DESIGN <i>PH</i>	DRAWN BY <i>PH</i>	DART AEROSPACE USA, INC. PORT HADLOCK, WA	
CHECKED <i>PH</i>	APPROVED <i>PH</i>	DRAWING NO. DSI 9319	REV. A SHEET 1 OF 1
DATE 06.01.09		TITLE WEARSHOE INSTALLATION	SCALE NTS
A	06.01.09	NEW ISSUE

DART SERVICE INSTRUCTION

TO AMEND INSTALLATION INSTRUCTIONS IIN-D412-742 REV. B
REF. FAA STC: SR01583SE
REF. CANADIAN STC: SH05-37 ISSUE 1

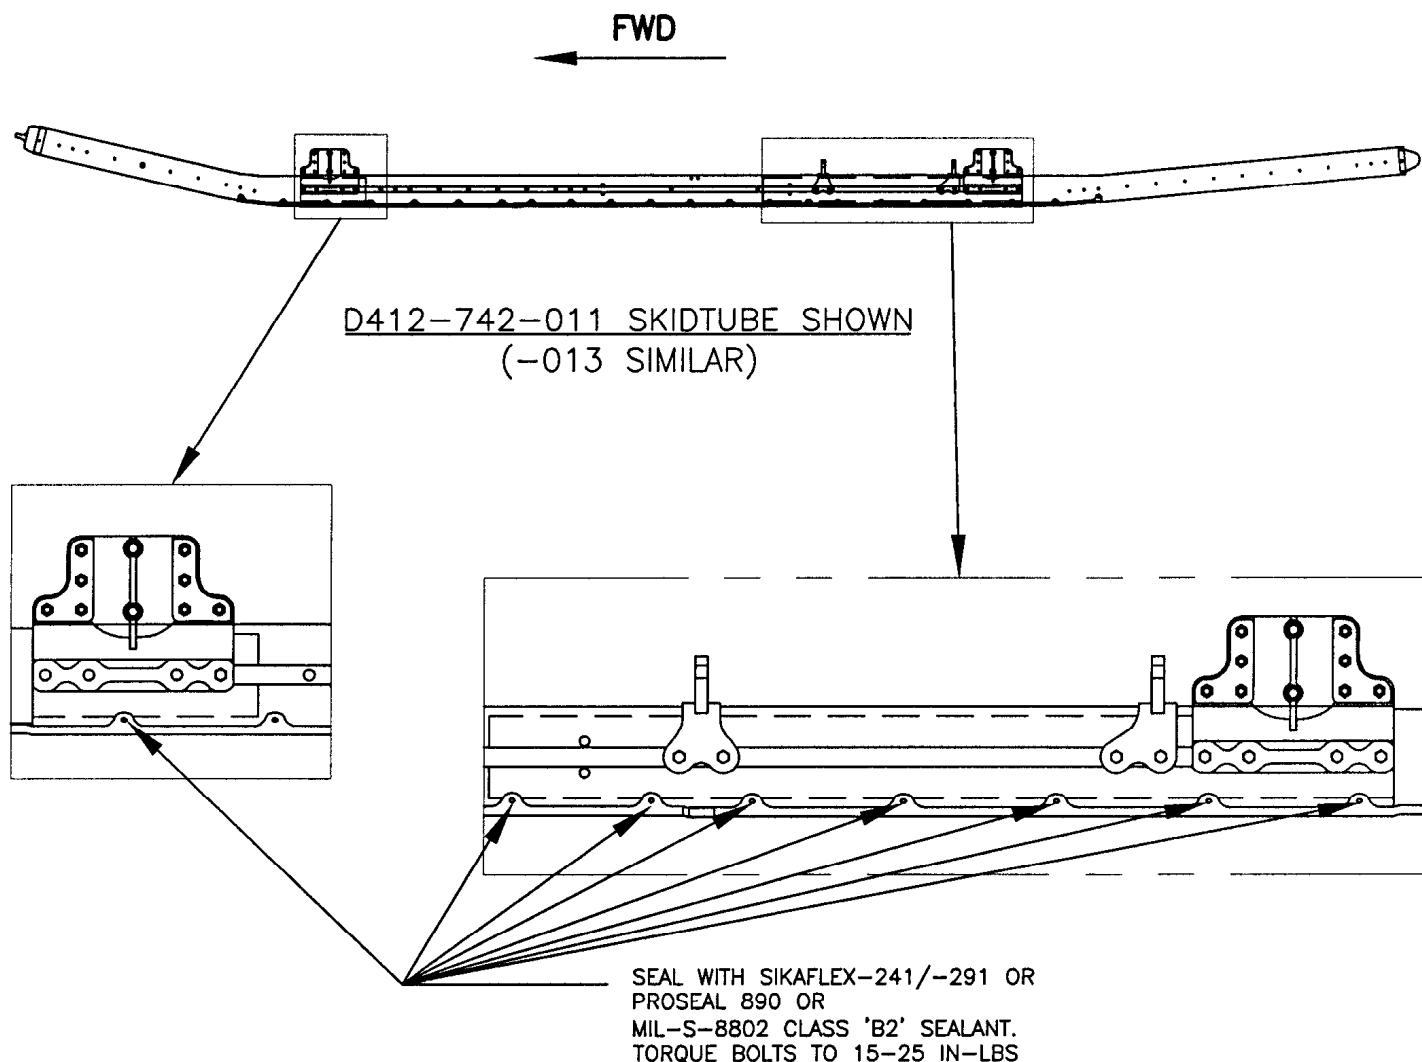
The wearshoe bolts that secure the fwd and aft extensions to the mid tube assembly have been left loose in shipping for easier installation.

To ensure proper fit between the wearshoes and skidtube, amend the installation procedure as follows before installing the assembled skidtube onto the crosstubes:

After loosely installing the fwd and aft saddles to the skidtube using the appropriate hardware, ensure AN3 wearshoe bolts that secure the fwd and aft extensions to the mid tube assembly (see below) are sealed with Sikaflex-241/-291 or Proseal 890 or MIL-S-8802 Class 'B2' sealant and properly torqued bolts to 15-25 in-lbs before installing the skidtube onto the crosstubes.
